MEMORANDUM

Permit: PE-7613

RE: Nickel Plate Mine/Barrick Gold Inc. Proactive Review

Reviewed by Leilane Ronqui, Environmental Impact Assessment Technician – Biologist
(Auxiliary), Mining Operations

Figure 1: EPT Index (A) and Relative Abundance (B) for Benthic Invertebrate Communities at Sites in Hedley Creek (figure 3.13 Barrick, 2018).

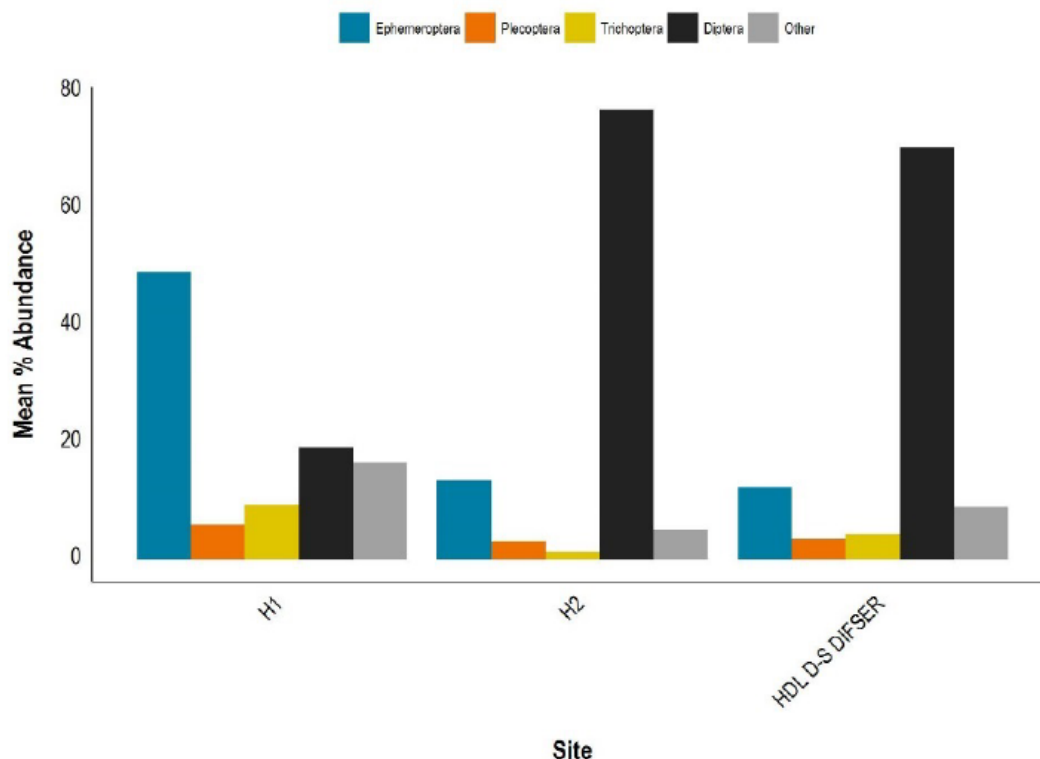
However, for the supporting endpoints Hilsenhoff's Biotic Index (HBI) and Ephemeroptera, Plecoptera, Trichoptera (EPT) abundance, there was significant difference between H1 and the exposure sites. H2 and HDL CREEK D-S DIFSER both had higher HBI values (4.9 and 5.0, respectively) than H1 (3.3), which indicate the presence of more pollution-tolerant taxa. H2 and HDL CREEK D-S DIFSER also had significantly lower proportions of the pollution-intolerant EPT taxa (22% and 27%, respectively) than H1 (69%), which indicates lower water quality (Figure 1, below – figure 3.13 Barrick, 2018). In summary, The HBI and EPT metrics indicated poorer water quality downstream from the diffuser than upstream for Hedley Creek.

In summary, an effect of mine discharges on the benthic invertebrate community in Hedley Creek was identified through the significant difference in density between reference and exposure sites, above the critical effect size, and significant differences in composition (Bray Curtis, evenness, diversity, HBI, and EPT abundance), below the critical effect size (Barrick, 2019).

The top three dominant benthic invertebrates at each site also indicate a change to poorer water quality downstream of the diffuser (e.g. =100 times more cobalt, ~30% more TSS, and ~30% less DO). At the reference site H1, the dominant taxa were all mayflies (39%) including Heptageniidae (recognized as indicators sensitive to metals in streams (Barrick, 2019)). At H2 and HDL CREEK D-S DIFSER, the communities were dominated by chironomids (recognized as robust taxa that tolerate a range of environmental stresses, including temperature, low oxygen, organic matter, sediment and contaminants).

Based on the *2018 Benthic Invertebrate Monitoring Program* data, a potential effect of mine effluent discharge on benthic invertebrate communities and periphyton biomass in the receiving environment was observed. The benthic invertebrate composition data added to the reported increment of periphyton biomass as chlorophyll *a* detected in H2 and HDL Creek D-S Diffuser and its association with the presence of Didymo (*Didymosphenia geminata*) (Barrick, 2019), which is an invasive species in western rivers in Canada and possesses a broad range of ecological tolerances (Campbell, 2005), supported assessment of the low quality of the water in Hedley Creek downstream of the discharge.

Recommendation: Additional monitoring should be conducted including periphyton tissue analyses, acute toxicity test using the invertebrate *Daphnia magna* and chronic toxicity test using the invertebrate *Ceriodaphnia dubia* in the receiving environment (H2 and HDL Creek D-S Diffuser) and compared with background characteristics of the region. The toxicological tests should be accompanied by surface water quality analysis. Particular attention must be given to the “parameters of potential concern” (ENV, 2019): sulphate, cyanide (SAD), thiocyanate, arsenic, cobalt, cadmium, zinc and selenium, given that the elevated levels of these elements, detected in the receiving environment of Nickel Plate Mine, have the potential to cause toxic effects and bioaccumulate leading to changes in populations of aquatic biota.
